Sales and Service

Change in Appearance of External Input Connectors of FX5-nSSC-S, LD77MS, QD77GF, and Q170MSCPU

3. Details of the Change

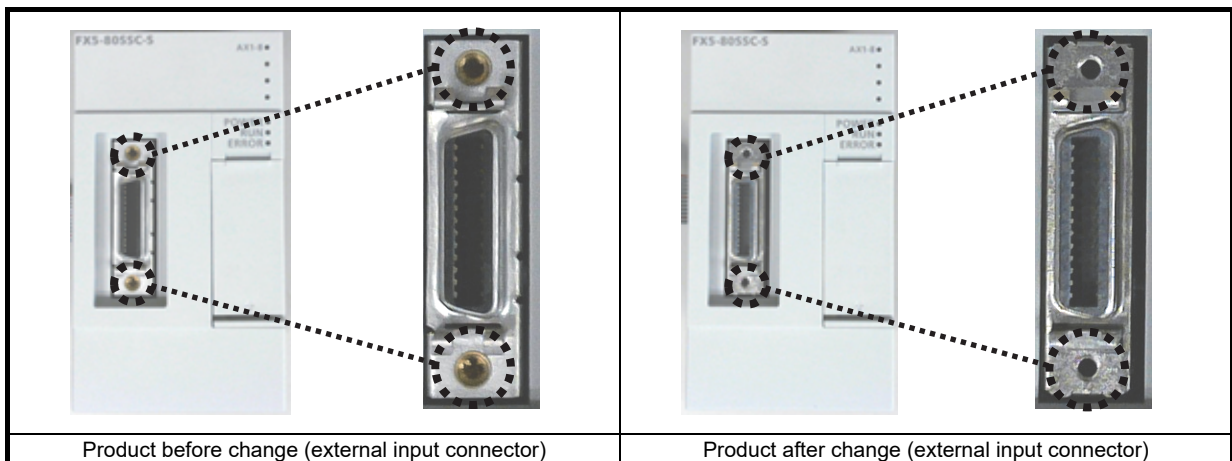
The external input connectors will have tapped holes instead of lock nuts. This change does not affect the functions and performance of the product. The recommended connector set LD77MHIOCON will fit into the changed connectors properly.
